Product Change Notification

Change Notification #: 113575 - 00
Change Title: Intel® Server System ER1304BTLSHBNR
PCN 113575-00, Product Design
Update Screws for Rack Ear Handles
Date of Publication: January 22, 2015

Intel is implementing the following change on the Intel® Server System ER1304BTLSHBNR:

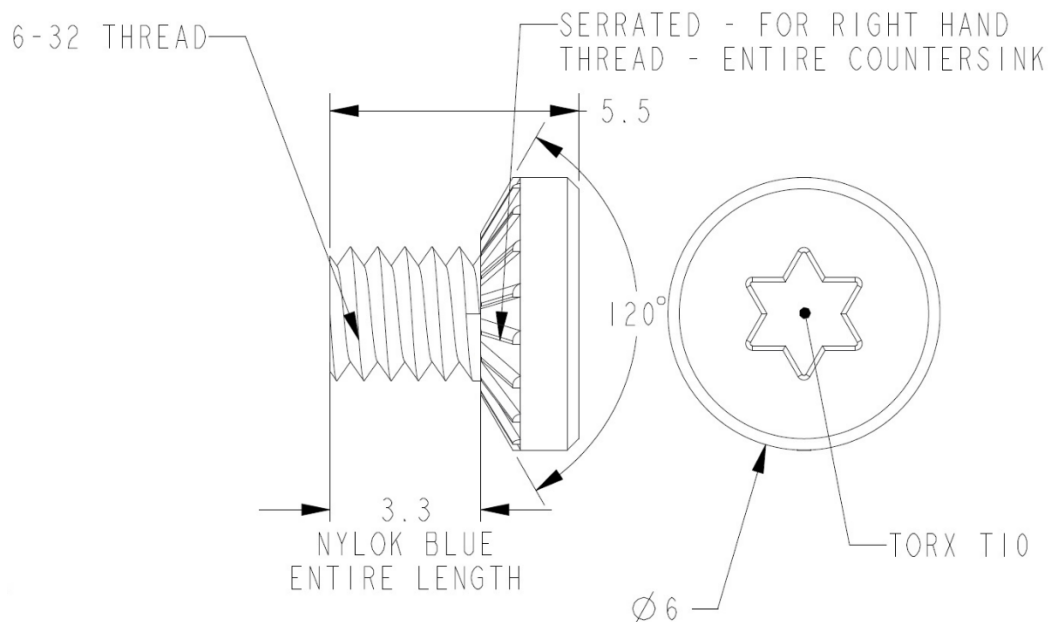
1. Update screws for the ear handles on both sides of the chassis.
 - Change the screw type. The new screw has a serrated Countersink feature.
 - Change the screw color to black.
 - Change the screw from T8 to T10.
 - Change the screw quantity from 6pcs to 4pcs.
